Subject: DEVIATION REVIEW AND DECISION FORM

**DEVIATION REVIEW
 AND DECISION FORM**

Subdivision or Project Name:
 PAINT BRUSH HILLS FILING 13E
 (Intersection Criteria and Tangent Length)

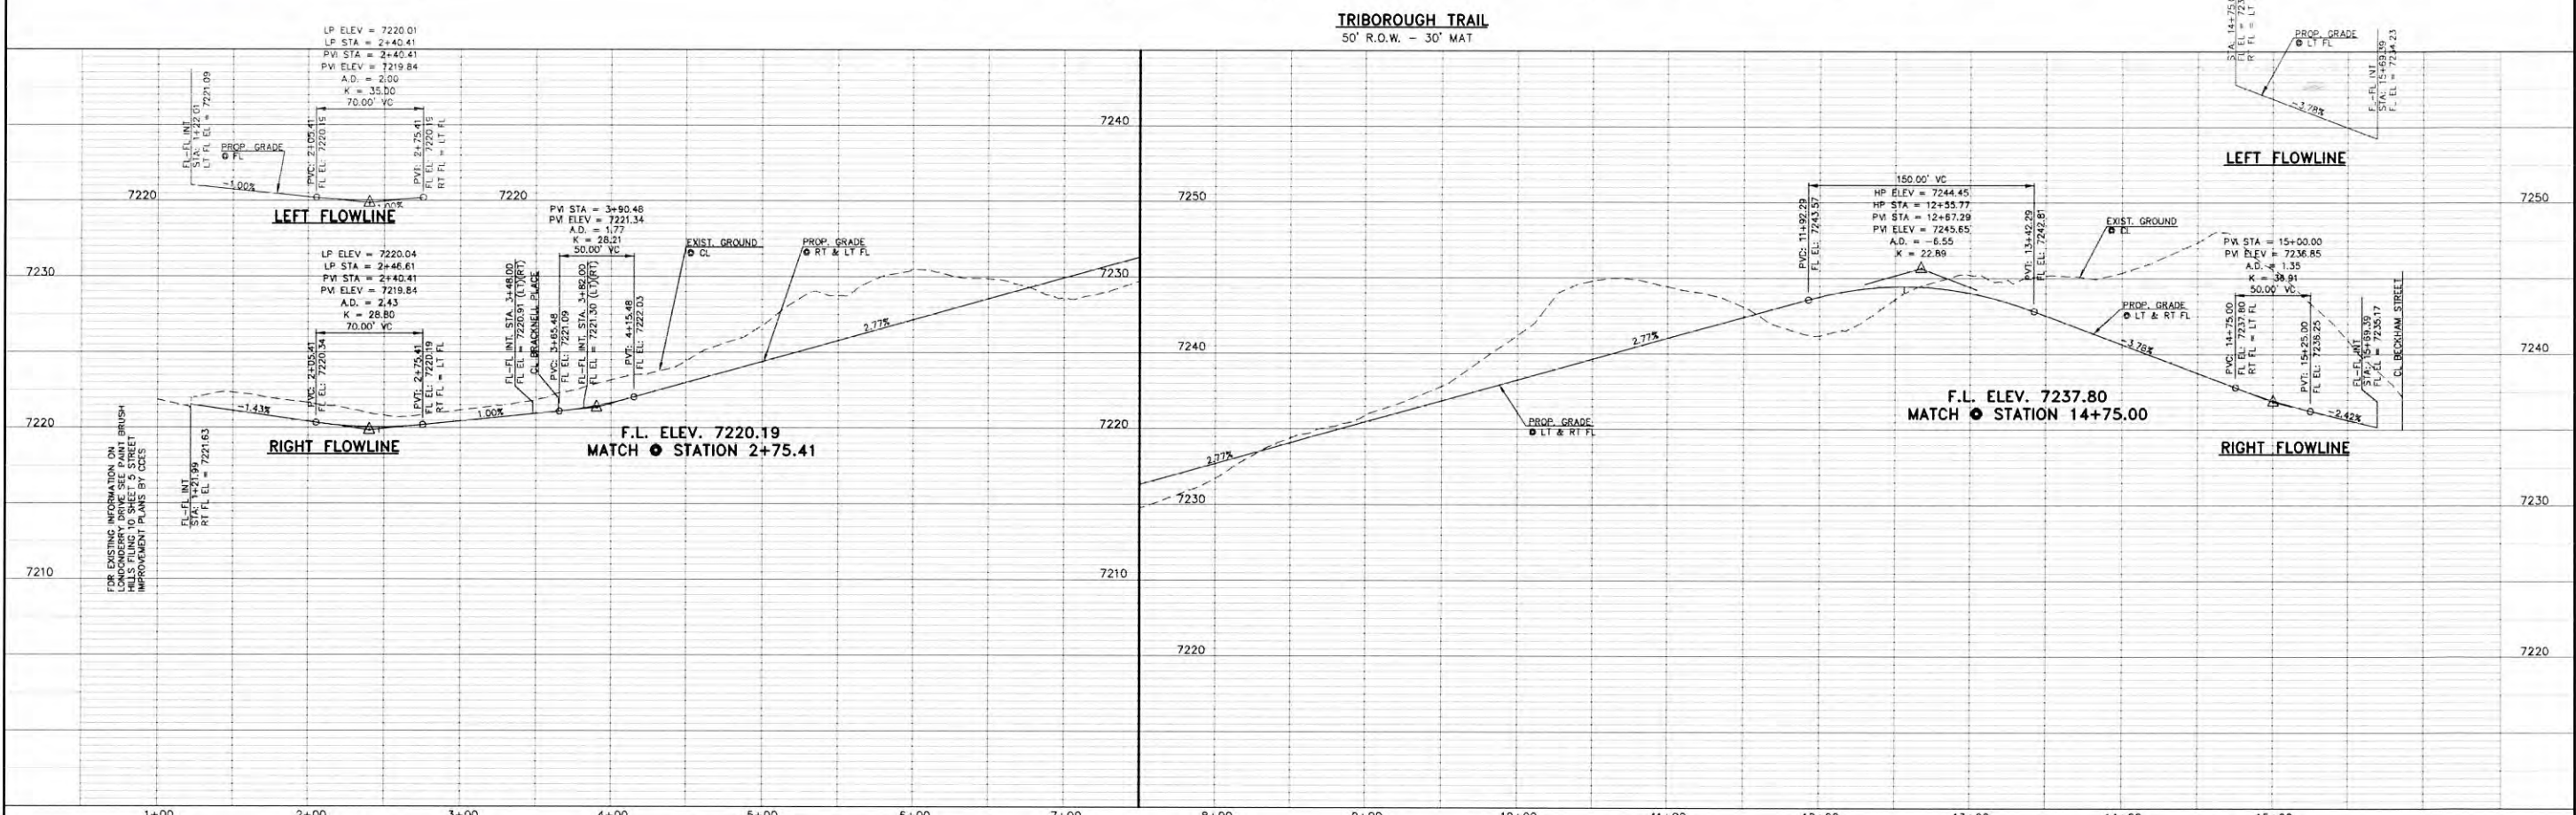
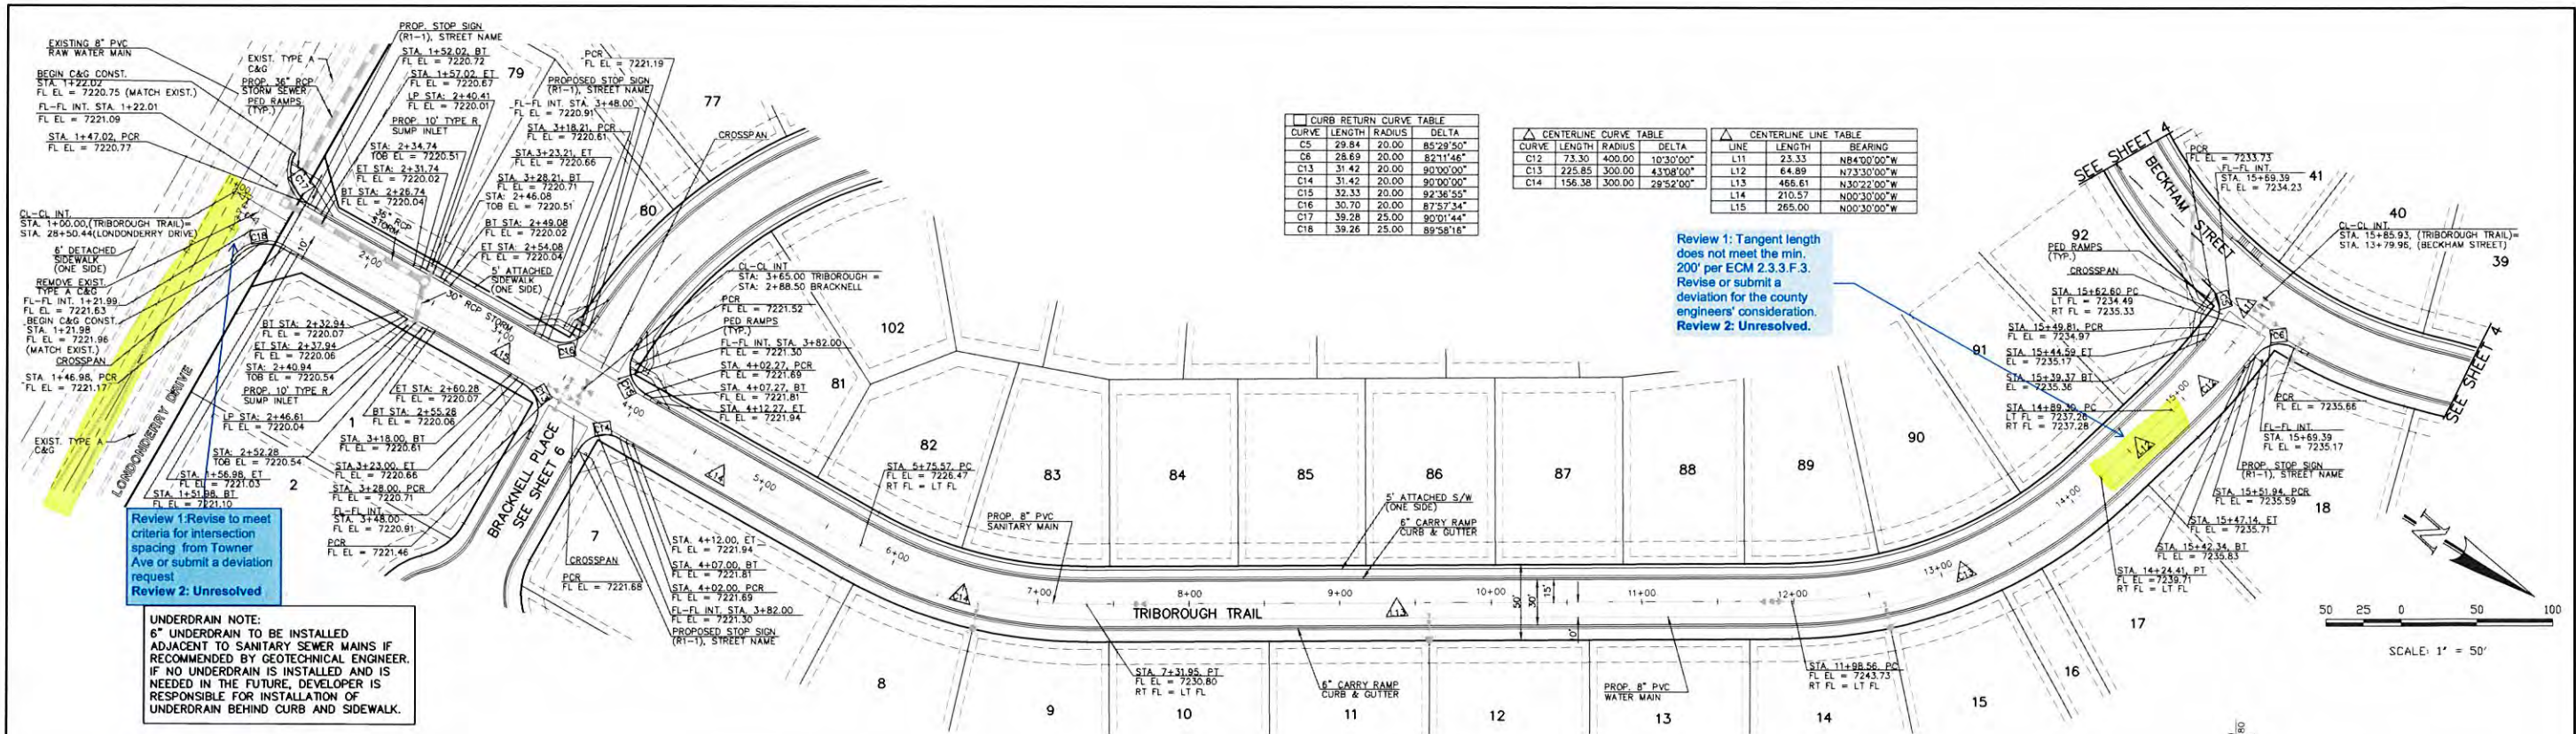
Review 1: Tangent length does not meet the min. 200' per ECM 2.3.3.F.3. Revise or submit a deviation for the county engineers' consideration.
Review 2: Unresolved.

Review 1: Tangent length does not meet the min. 200' per ECM 2.3.3.F.3. Revise or submit a deviation for the county engineers' consideration.
Review 2: Unresolved.

PAINT BRUSH HILLS FILING 13E
CONSTRUCTION PLANS
STREET IMPROVEMENT PLANS
BECKHAM STREET
DESIGNED BY: MAW SCALE: DATE: 7-20-18
DRAWN BY: MAW (H) 1" = 50' SHEET 4 OF 17
CHECKED BY: (V) 1" = 5' JOB NO. 2053.50

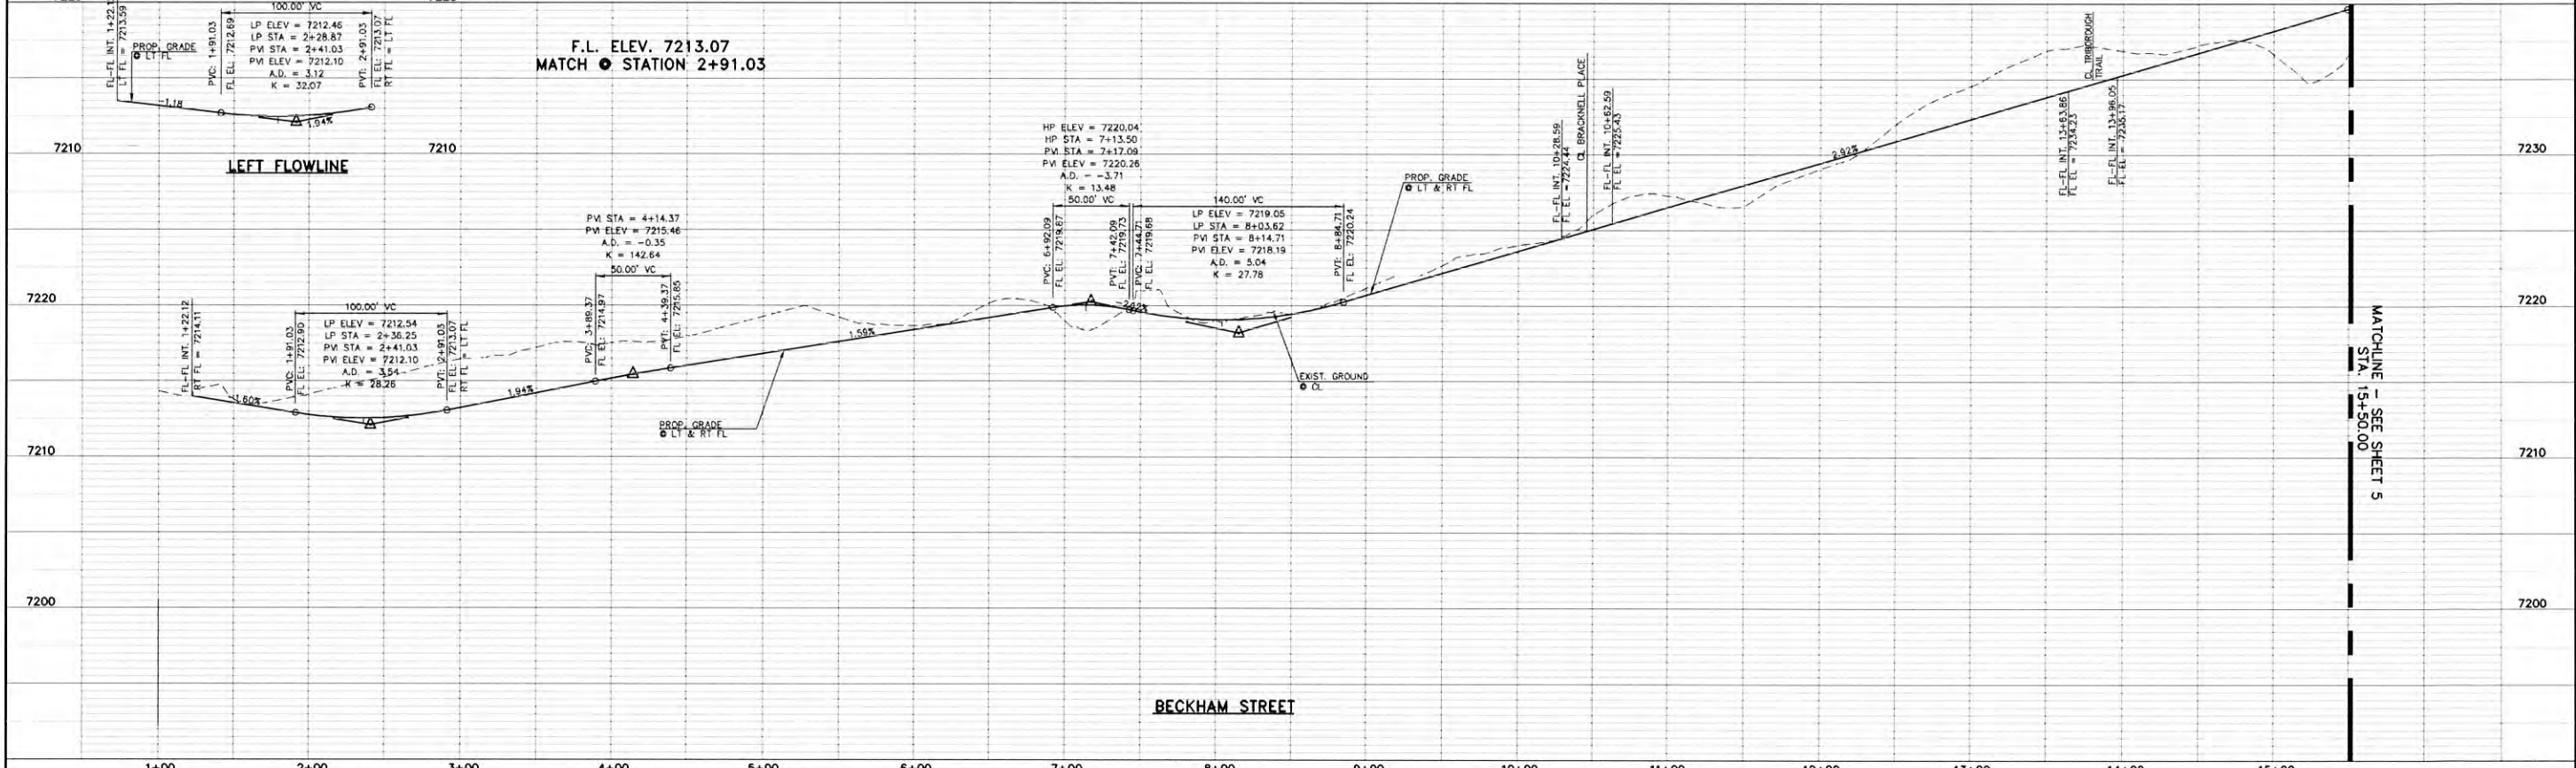
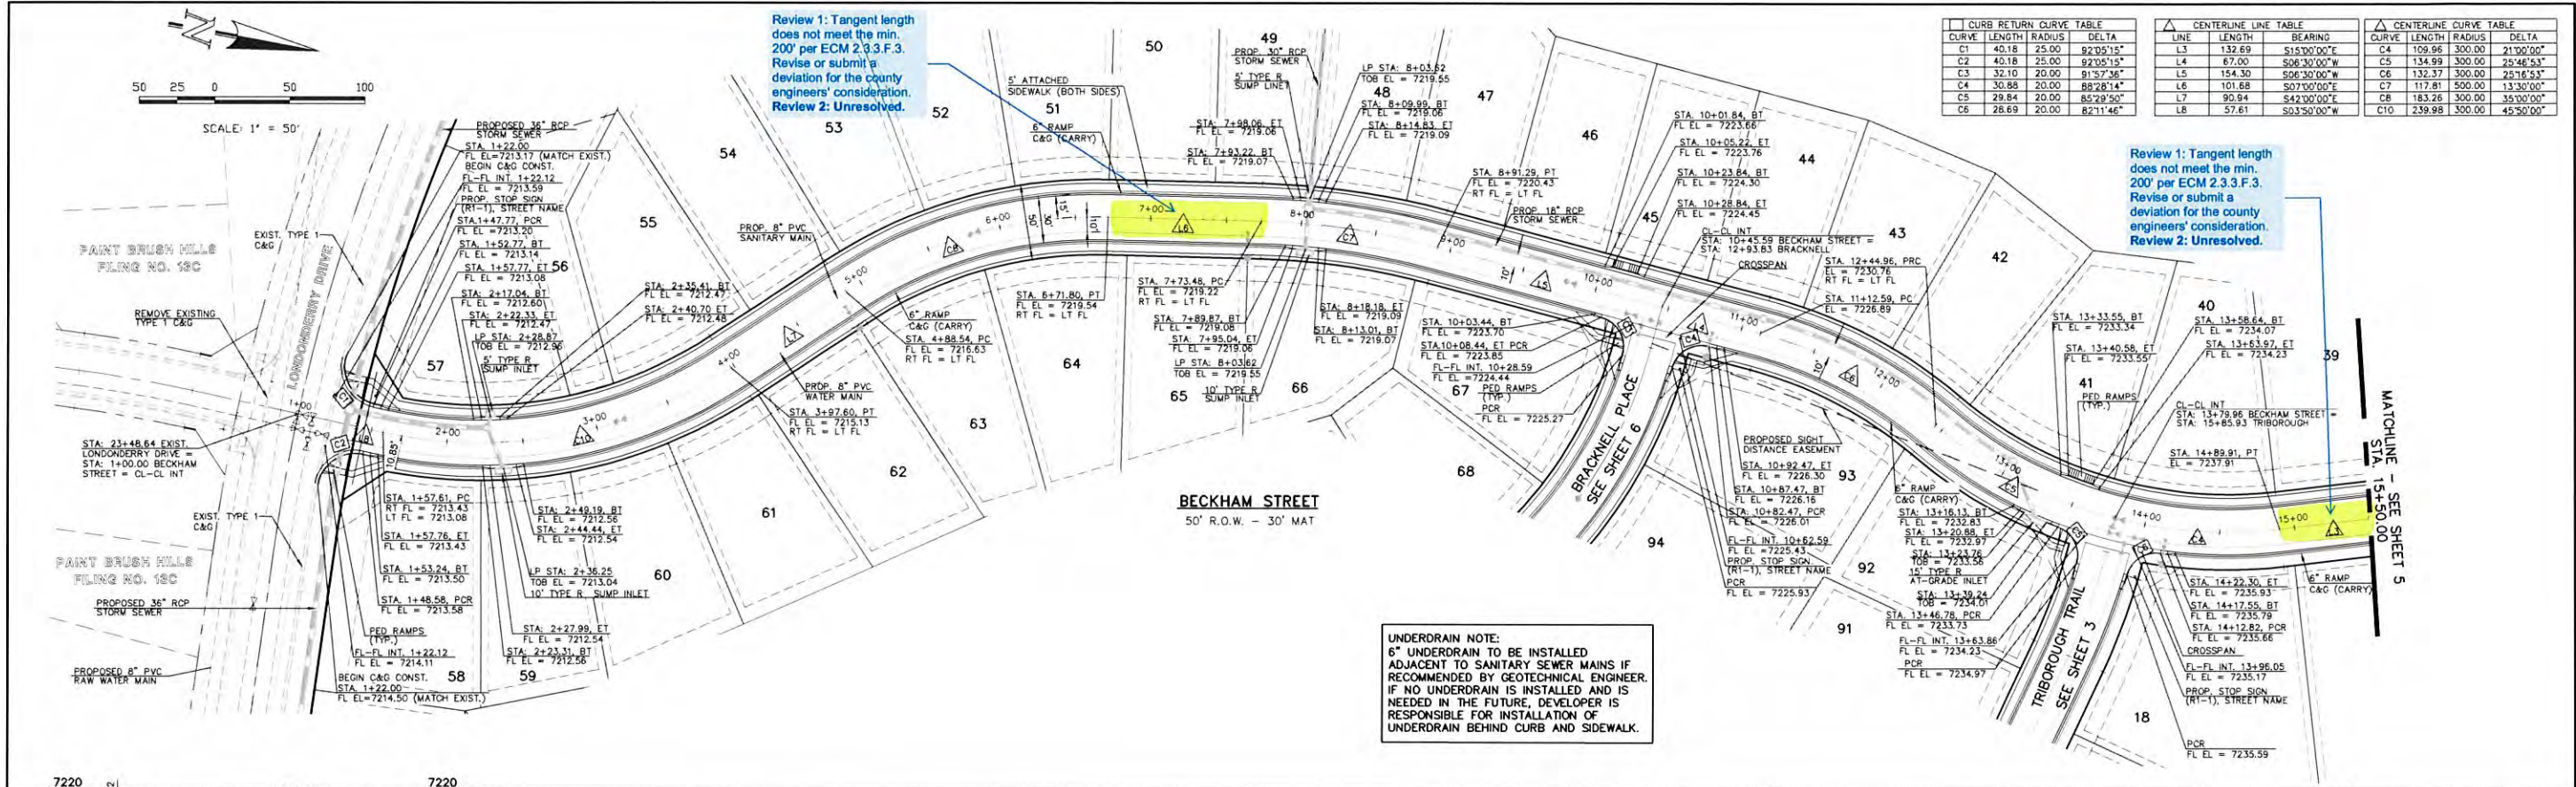
Review 1: Tangent length does not meet the min. 200' per ECM 2.3.3.F.3. Revise or submit a deviation for the county engineers' consideration.
Review 2: Unresolved.
